City of Albuquerque

**RE: BANDELIER ELEMENTARY SCHOOL - NEW MAIN ENTRANCE (L16-D28A).
Revised GRADING PLAN FOR BUILDING PERMIT APPROVAL. ENGINEER'S
STAMP DATED April 24, 2001.**

**Re: Bandelier Elementary School New Main Entrance Grading Plan
Engineer's Stamp dated 3-28-01, (L16/D28)**

**Re: Bandelier Elementary School Grading and Drainage Plan Addendum
3309 Pershing SE
Engineer's Stamp dated 12-12-07, (L16/D28)**

BANDELIER ELEMENTARY SCHOOL
CHANGE ORDER #1, SHEET C-112 R1

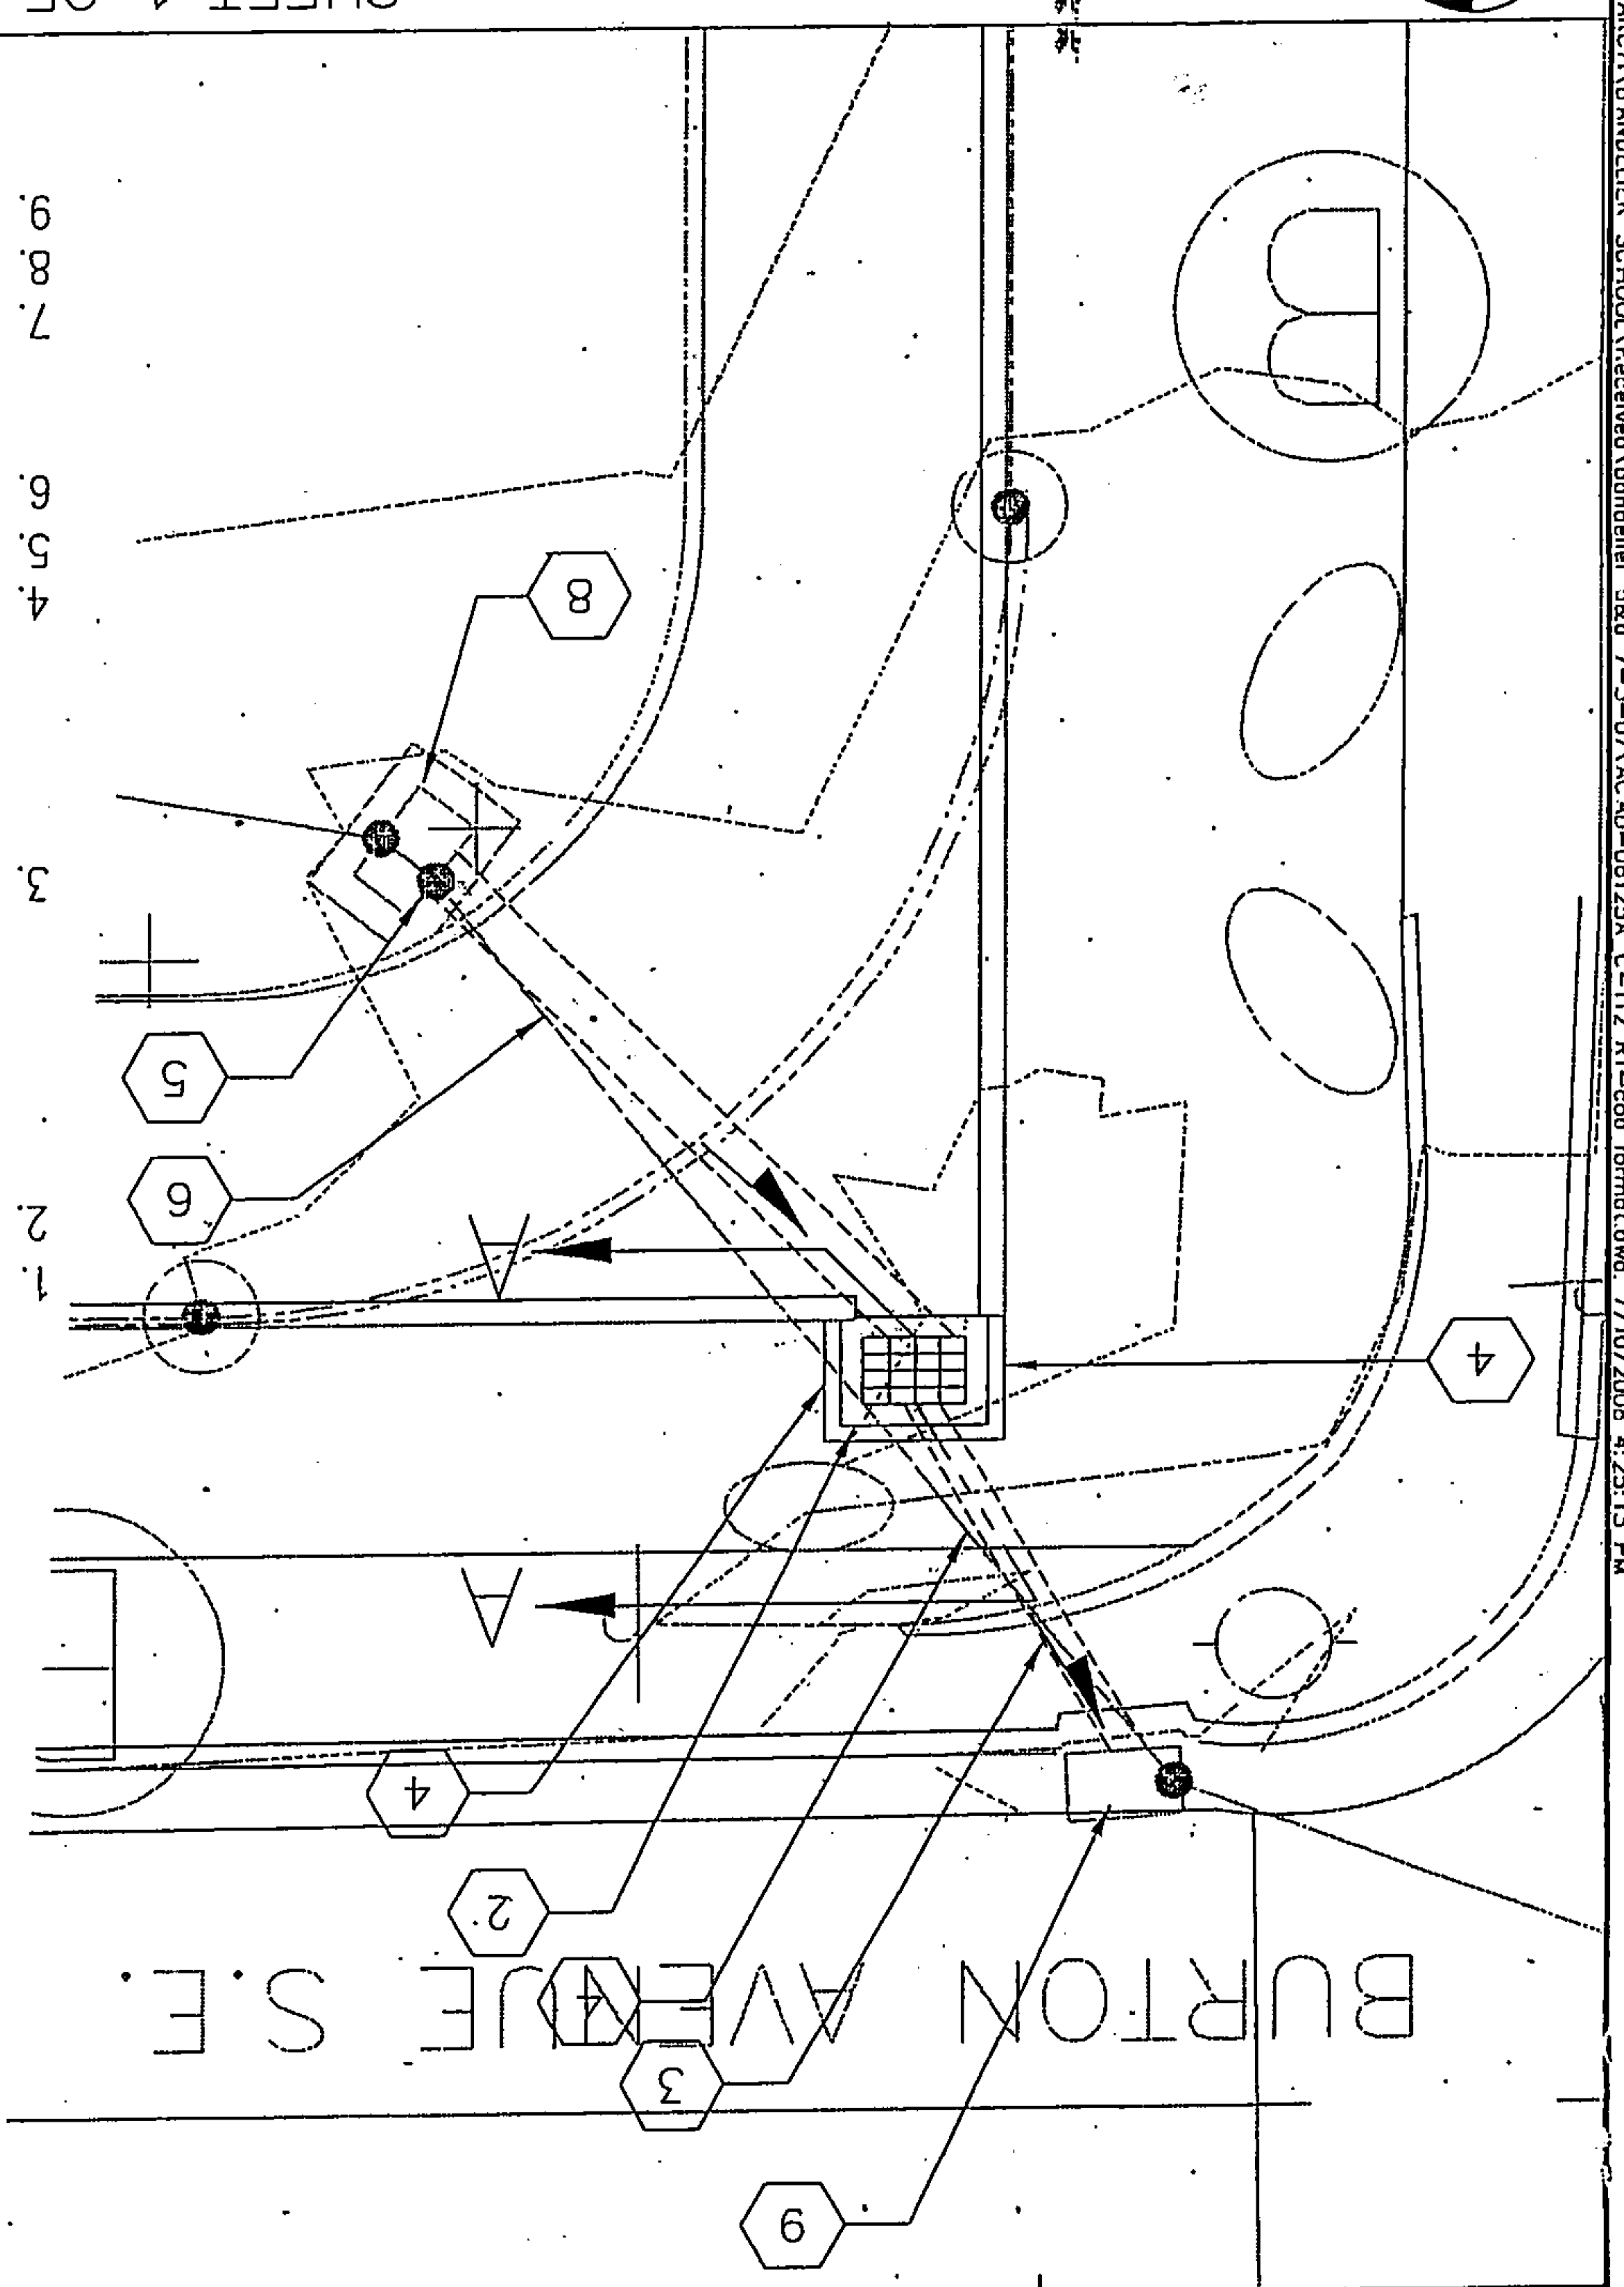
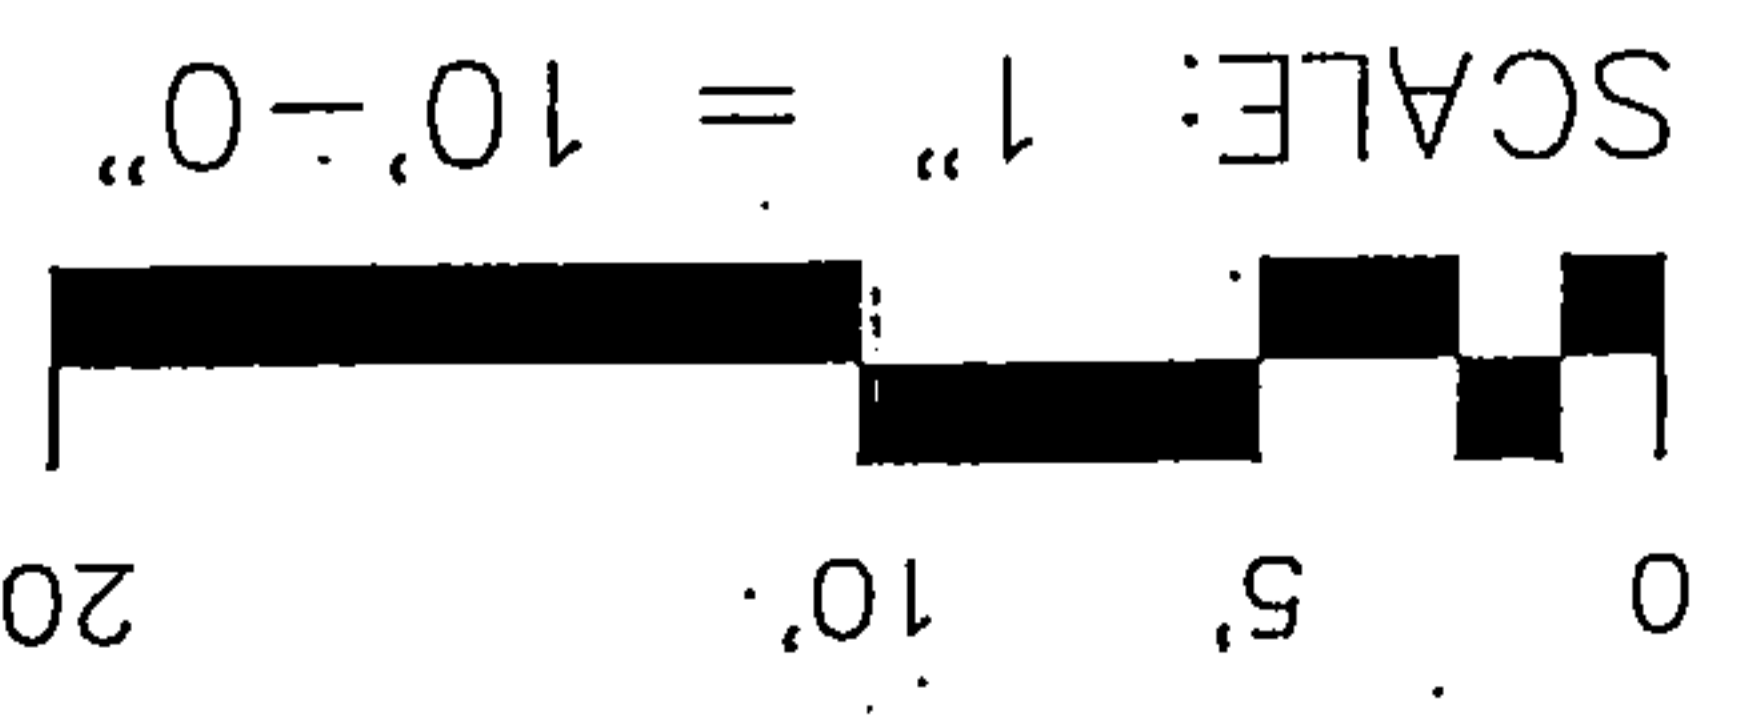
1. DELETED.
2. NEW SINGLE TYPE "D" DRAIN INLET PER COA STANDARD DRAWING #2206
TOP OF GRATE=~~50.3~~ **50.30**
INVERT (IN)=~~47.01~~ **47.08**
INVERT (OUT)=~~47.01~~ **47.08**
N: 5630.69
E: 5040.99
3. NEW 12" ϕ x 13' HDPE STORM DRAIN PIPE, S=1.5%, CONNECT TO EXISTING CURB DI IN STREET. CONTRACTOR TO FIELD VERIFY INVERT OF EXISTING CURB DI PRIOR TO CONSTRUCTION.
INVERT(IN)=~~47.01~~ **47.06**
INVERT(OUT)=~~46.81~~ **46.94**
SEE ORIGINAL STAMPED DRAWING.
4. SEE ORIGINAL STAMPED DRAWING.
5. SEE ORIGINAL STAMPED DRAWING.
6. NEW 18" ϕ x 22' HDPE STORM DRAIN PIPE, S=~~0.15%~~ **0.1%**
INVERT(IN)=~~47.11~~ **47.07**
INVERT(OUT)=~~47.01~~ **47.06**
7. DELETED.
8. SEE ORIGINAL STAMPED DRAWING.
9. EXISTING CURB DI. REMOVE ALL SILT AND DEBRIS AND FILL INVERT OF DI TO EXISTING DRAIN PIPE ELEVATION (INVERT=46.71) WITH CONCRETE, SLOPE INVERT TO DRAIN TO EXISTING DRAIN PIPE.

Based upon the information provided in your submittal received 7-11-08, the above referenced change order is approved for Building Permit & SO 19 Permit, with the condition that the pipe connection to existing City inlet must be sealed with non-shrink grout.
